CITY OF ALBUQUERQUE

RE: Winrock Hotel
2100 Louisiana Blvd.
Grading and Drainage Plan Stamp Date: 3/8/22
Hydrology File: J19D058I

Based on the submittal received on 3/11/21, the Grading Plan cannot be is approved for Building Permit until the following items are addressed:

TITLE: **GRADING PLAN**

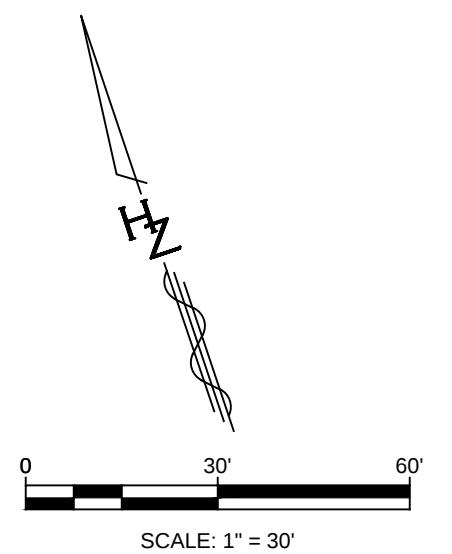
1. Per the DPM, the Grading plan should be at 1"=20" to make the plan readable.
2. Please provide management onsite for the Stormwater Quality Volume (SWQV) in accordance with the drainage ordinance, § 14-5-2-6 (H) enacted 10/2/18 (Council Bill C/S O-18-2). Please show the top and bottom of the ponds along with the volume for each pond. The onsite drainage should be directed to these ponds prior to being discharge into Indian School. Please follow the DPM (signed 06/08/20) Article 6-12 Stormwater Quality and Low-Impact Development for the sizing calculations. To calculate the required SWQV, multiply the impervious area draining to the BMP by 0.42 inches for new development sites and 0.26 inches for redevelopment sites. The calculations of both the required and the provided volume of each BMP must be shown on the Grading and Drainage Plan. Each BMP should be labeled on the Grading and Drainage Plan with the required SWQV and associated water surface elevation and the 100-year water surface elevation. Landscaping of surface BMPs is also required to be noted on the Grading and Drainage Plan.

3. Please number the ponds and include a label on each with the SWQV and elevation, the 100-year volume and elevation, the peak 100 year inflow and outflow, the spillway crest elevation, the spillway flow depth, and the dam top elevation.

TITLE: **DRAINAGE PLAN**

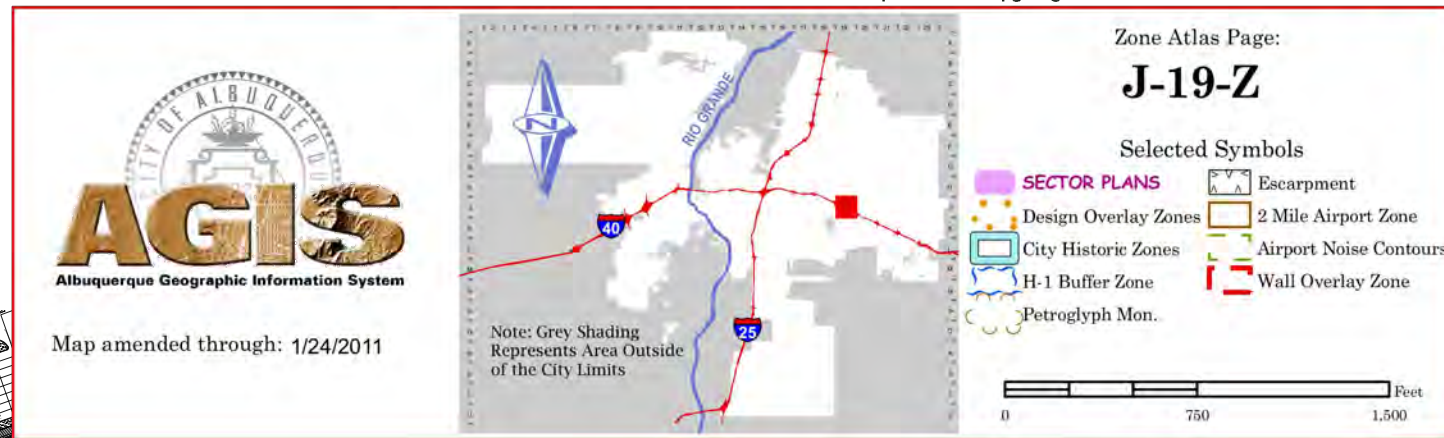
4. Please provide the SWQV calculations for each basin draining to each pond. The stormwater quality ponds need to be sized for the areas draining to them

5. The calculations used are incorrect. The numbers used are from DPM chapter 22 which is now outdated. Please use the revised DPM chapter 6 for all calculation. Also, you

calculated the site as Land Treatment B when the entire site is Land Treatment D for both existing and proposed.

6. The cost for Payment-in-Lieu you have used is incorrect. You calculated using \$7/CF where it should be \$8/CF.
7. If you are not providing enough ponding for SWQV and would like to request Payment-in-lieu then you must fill out and submit a waiver for this. I will include the waiver request form with this letter. Please be aware that submitting for a waiver does not mean that you will receive it, Hydrology is reviewing waiver requests very carefully and most sites will not qualify. Please recheck you volume requirements as your calculations were done using the old DPM numbers.
